Project Title: Chick-fil-A at Gibson Building Permit #: _____ City Drainage #: _____

Re: **Chick-fil-A**
1600 Gibson Blvd. SE
Grading and Drainage Plan
Engineers Stamp Date 12/15/14 (M12-D015C)

Merrick & Company has reviewed the comments received on February 26, 2015 regarding the proposed Chick-fil-A located at 1600 Gibson Blvd. SE. The following summarizes Merrick's response to the comments provided by the City of Albuquerque.

Sheet
C-3.0

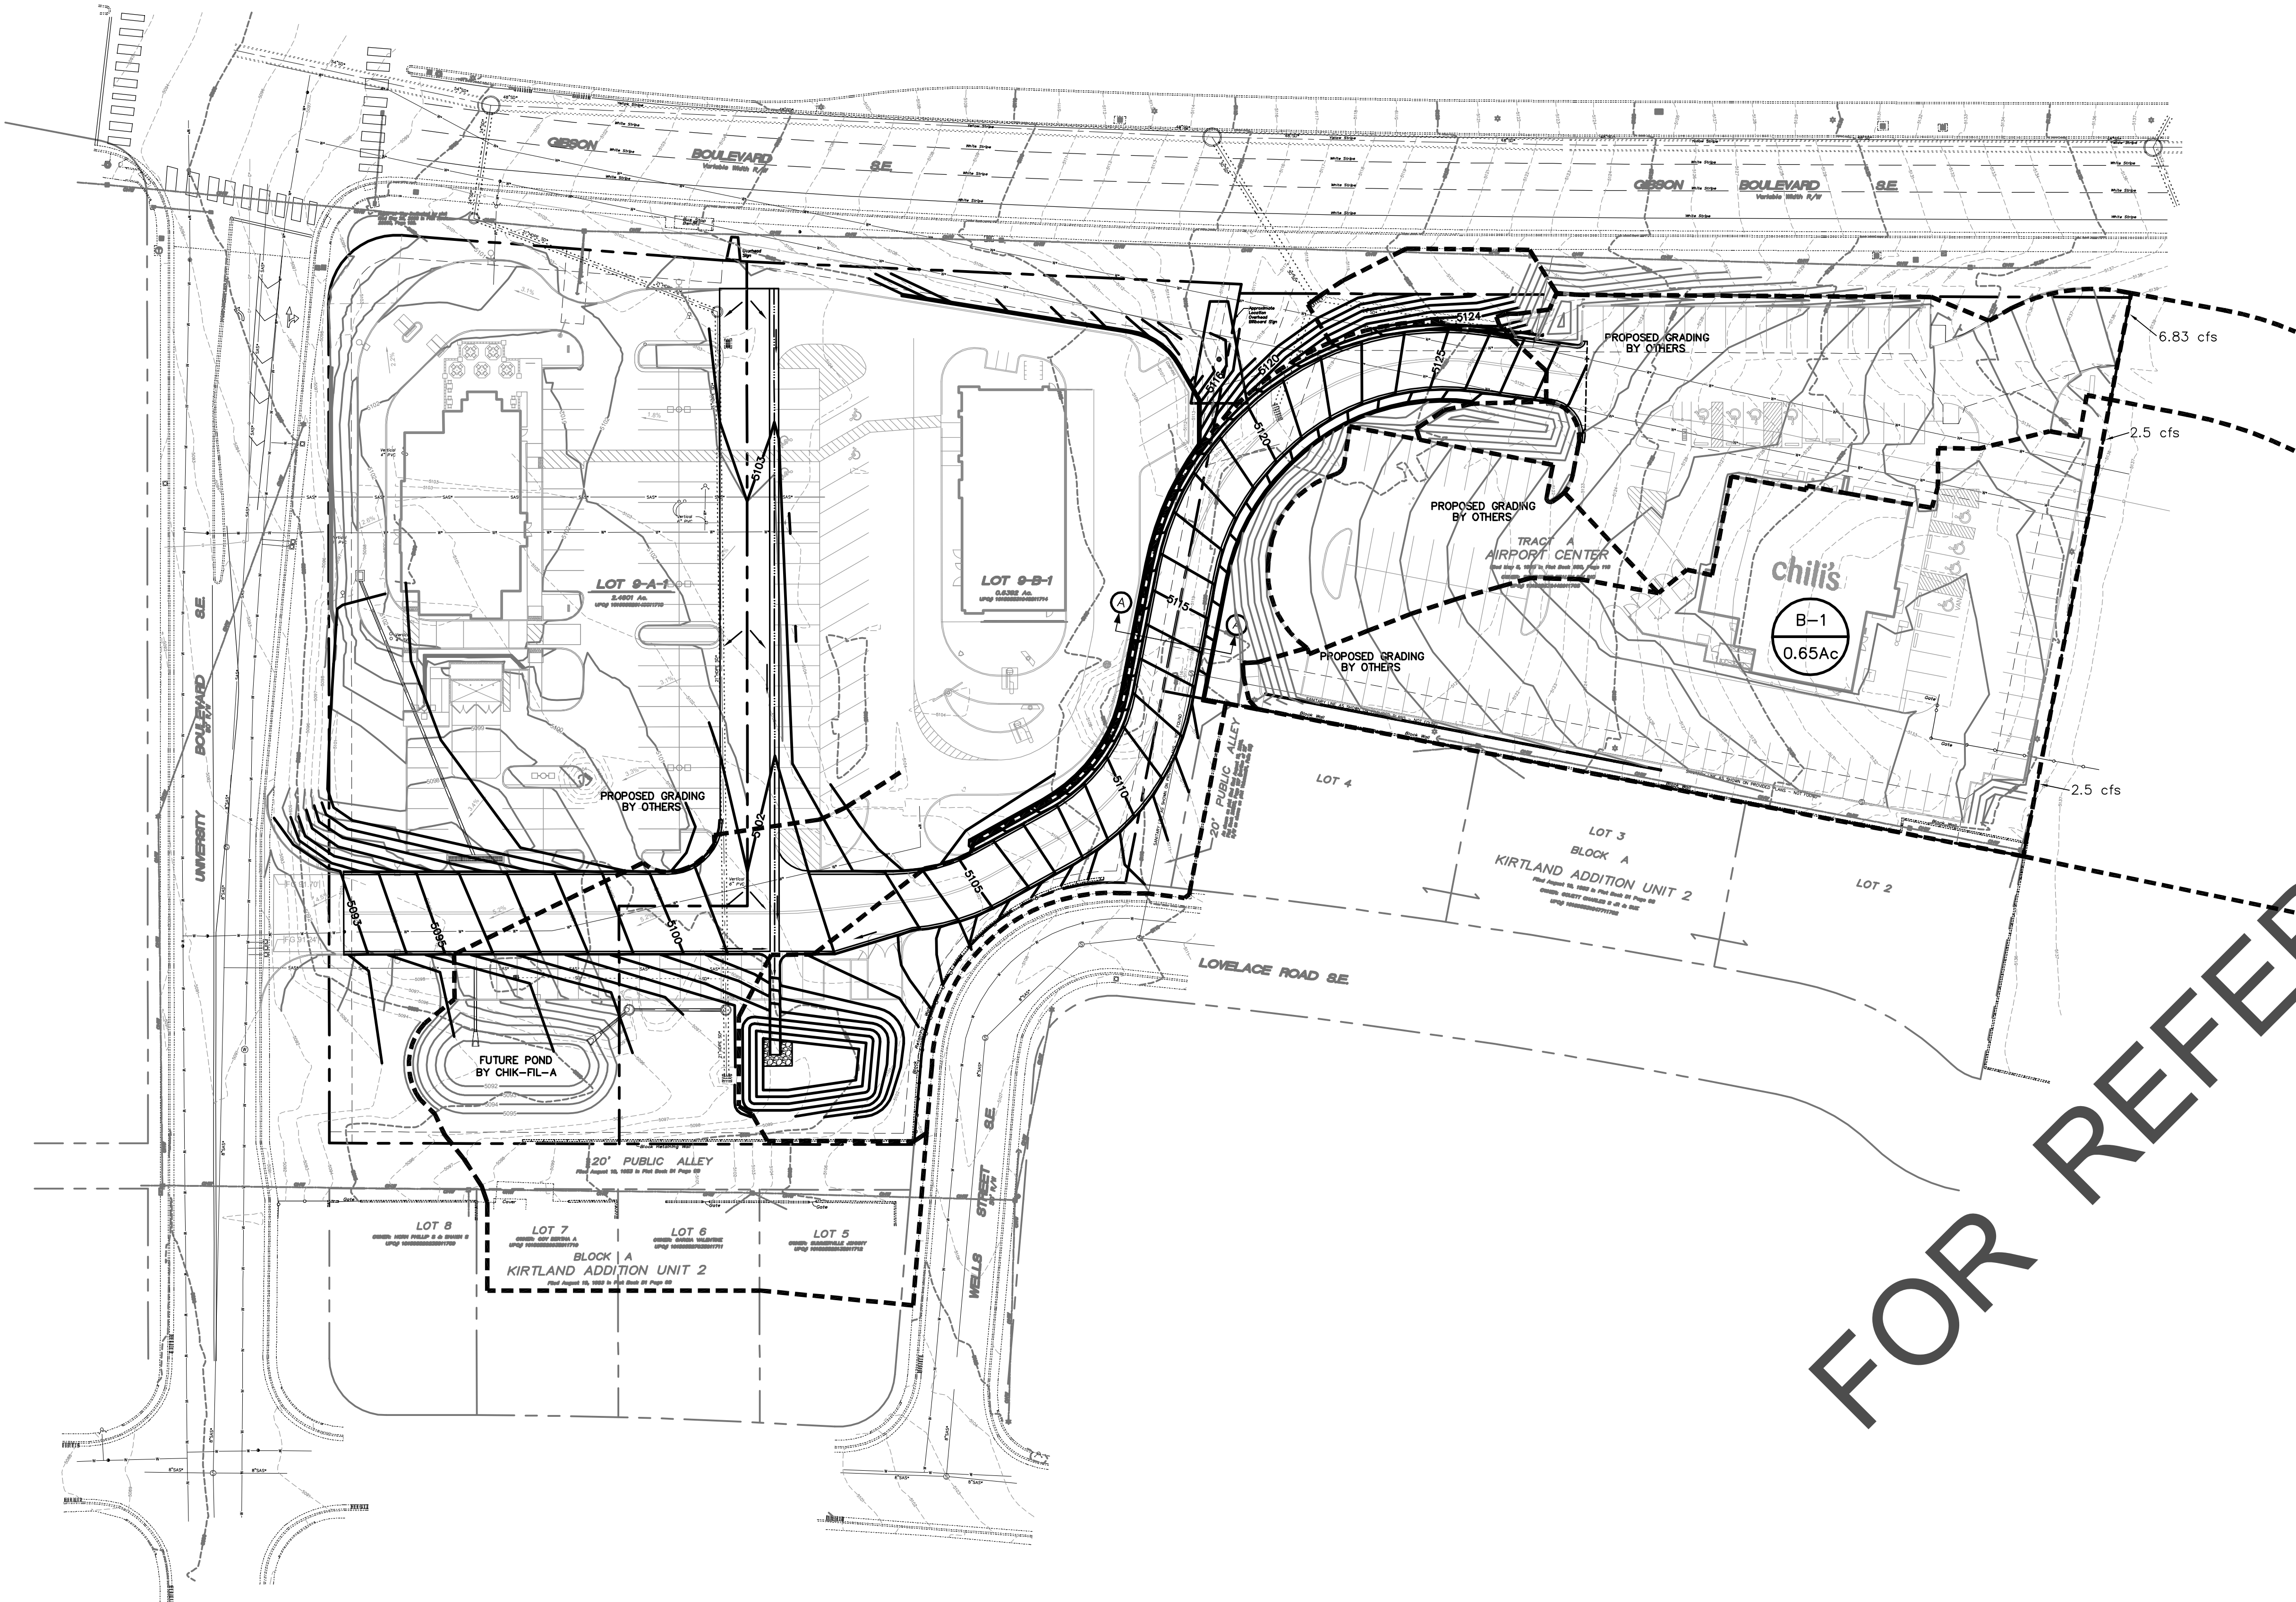
- The plan would be easier to review if sheets C-3.0 & C-3.1 or provide build notes on sheet C-3.0 to get rid of Sheet C-3.1. The storm plan can also be added to sheet C-3.0 and the profiles can be reduced and added to the basin map. Sheet C-3.3 can be deleted if references to these profiles are made on the sheet C-3.0. Also, when time comes to submit for Certificate of Occupancy, fewer sheets will need to be certified.

- There appears to be a ponding area in the drive up lane.

Response: The sheets have been altered to make reviewing clear and easy.

Response: The grading has been adjusted to remove ponding area.

Overall Drainage
Management Plan

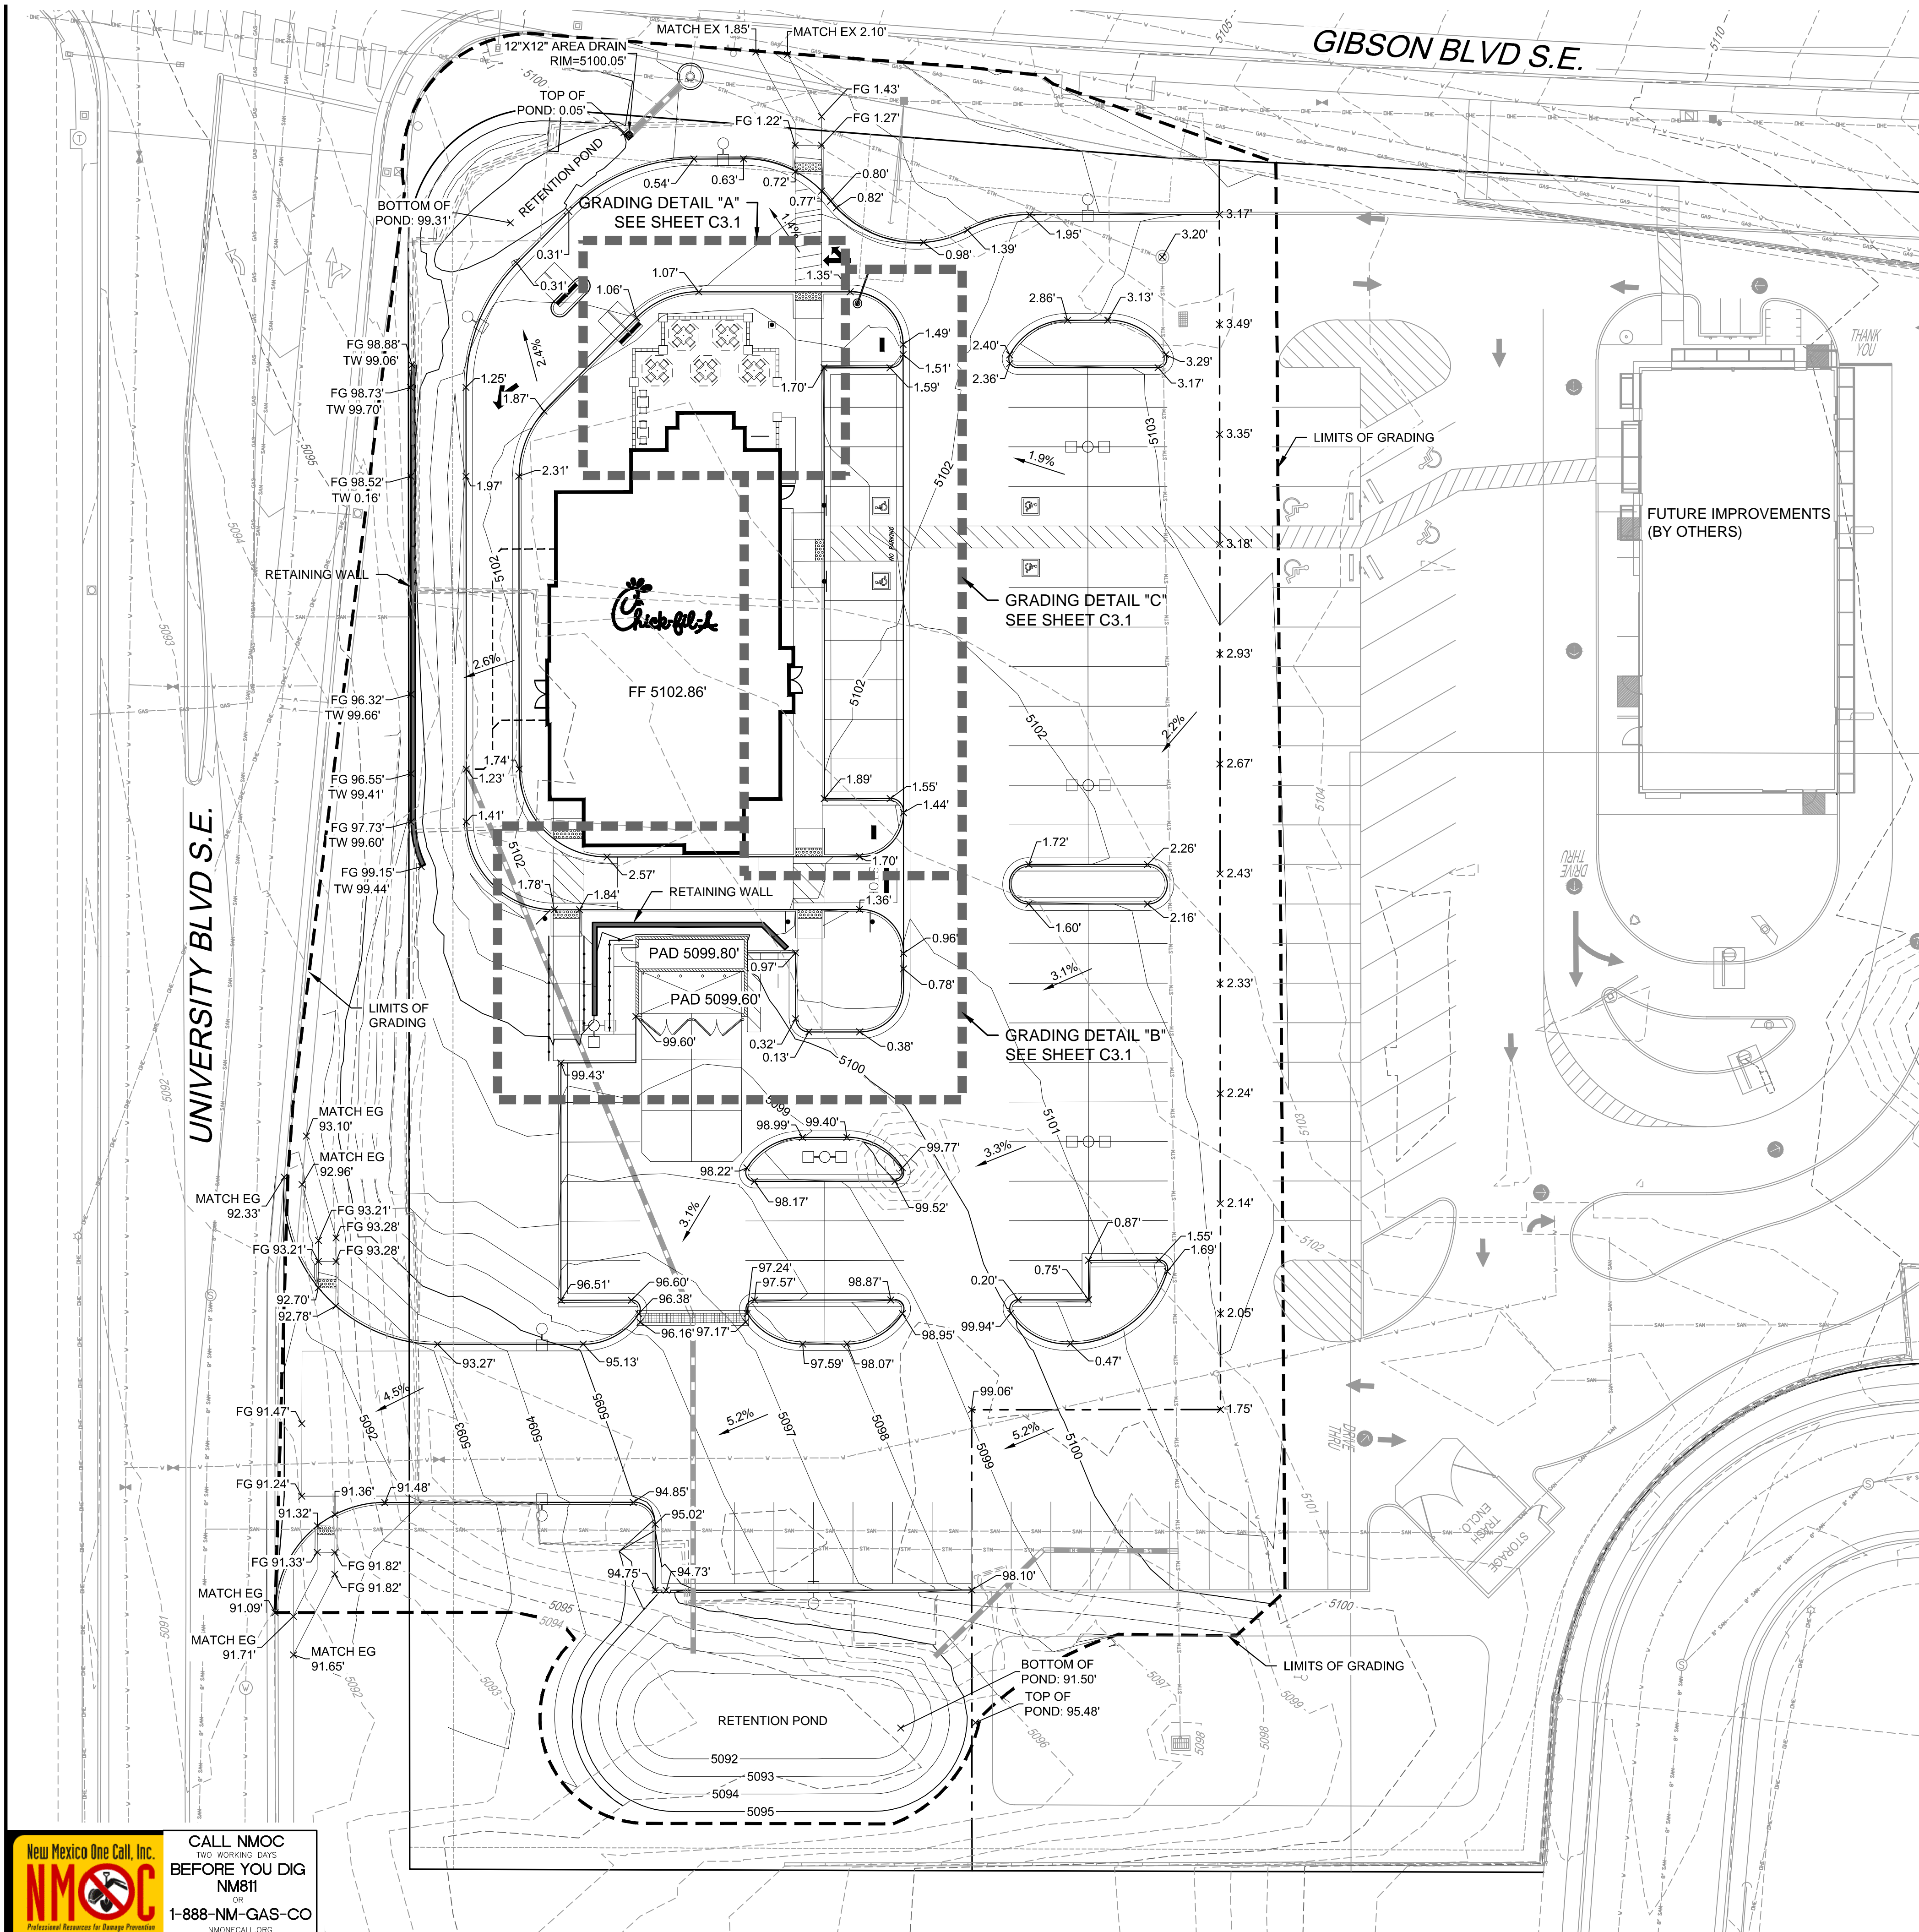
- This site should be presented as a stand-alone site accepting off site flows from the east. The commercial sites to the east have not been built and may not be built due to some complications with the vacation of Miles road.

Response: Offsite drainage will be provided by the developer. Please refer to sheet C-2.0 for the overall drainage map as a reference.
